ANDAH ELECTRONICS(SHENZHEN)LTD.	
MODEL: MP868W	
SHEET: 1 OF4	Issued:
REV: A2	APPROVED:
NO: FMP868WCD0196	CHECKED:
DATE: 2007.10.30	DESIGNED:

ANDAH ELECTRONICS(SHENZHEN)LTD.		
MODEL:	MP868W	
SHEET:	3 OF4	Issued:
REV:	A2	APPROVED:
NO:	FMP868WCD0196	CHECKED:
DATE:	2007.10.30	DESIGNED:

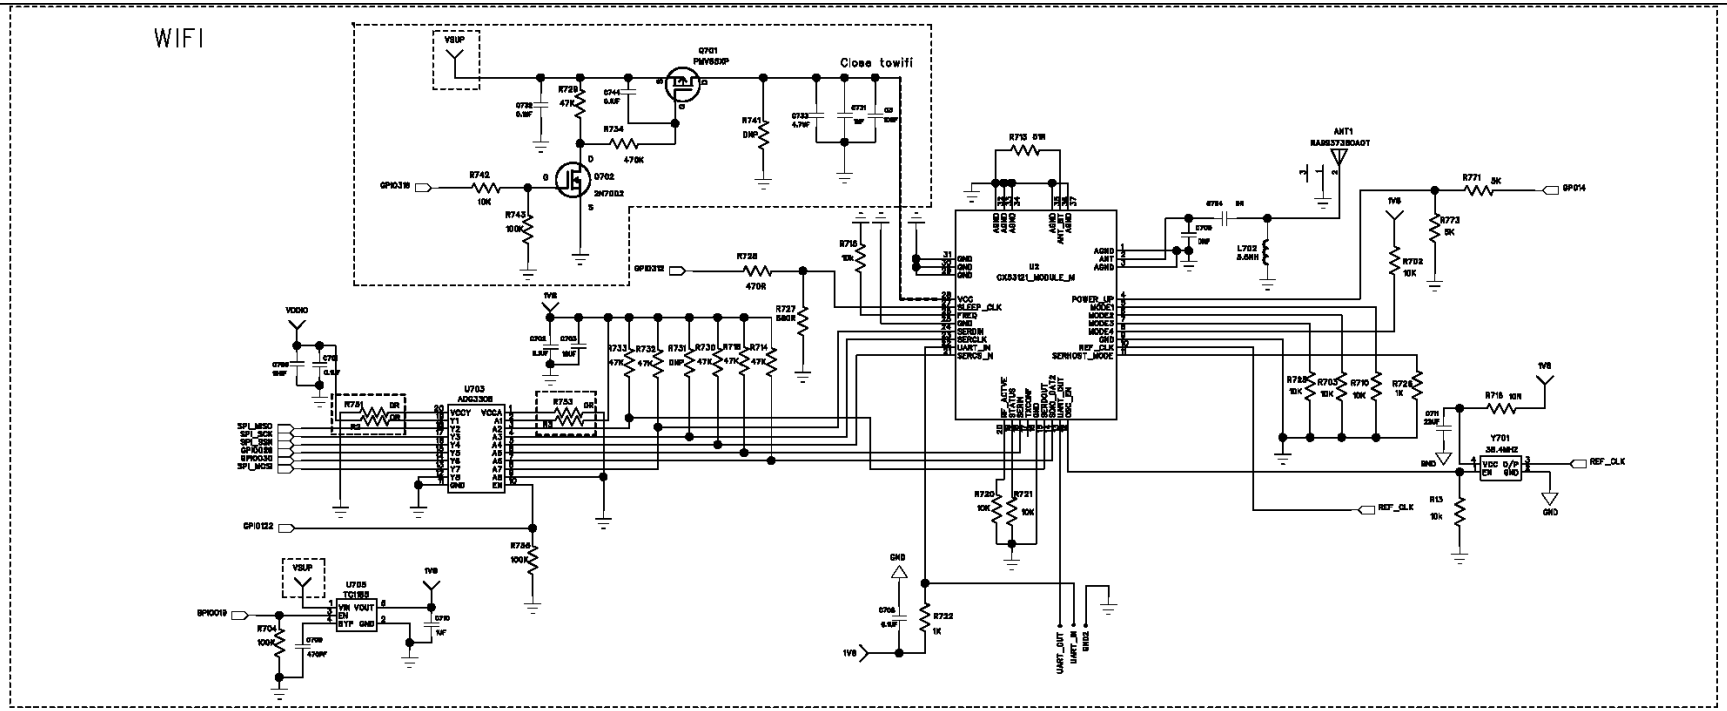
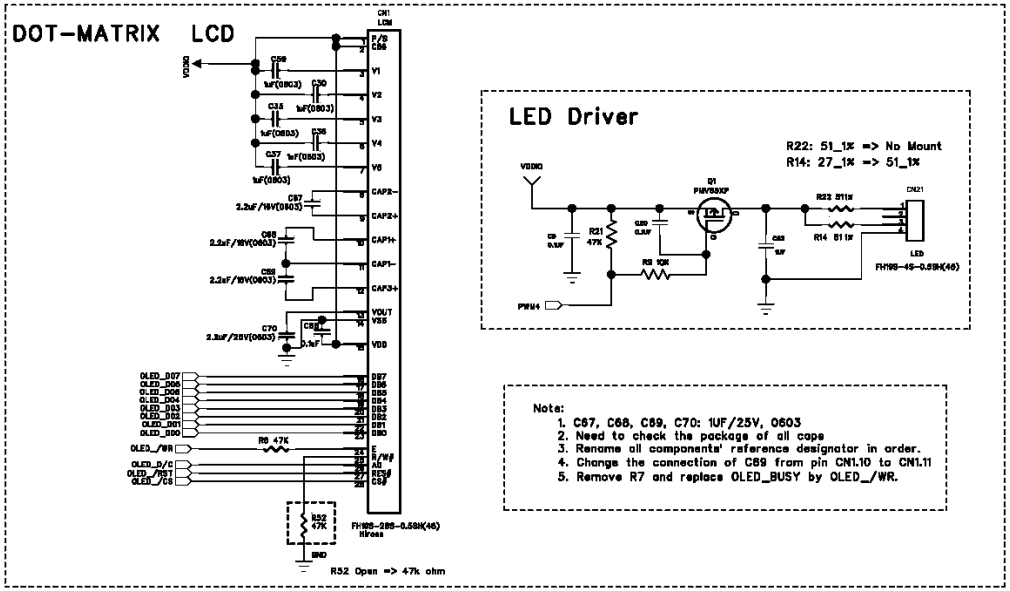
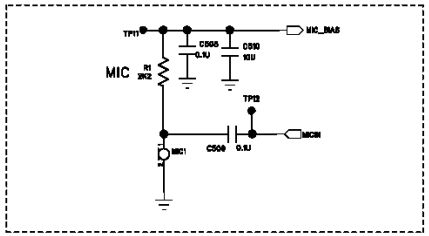
Note:
1. C67, C68, C69, C70: 1UF/25V, 0603
2. Need to check the package of all caps
3. Rename all components' reference designator in order.
4. Change the connection of C69 from pin CN1.10 to CN1.11
5. Remove R7 and replace OLED_BUSY by OLED_/WR.
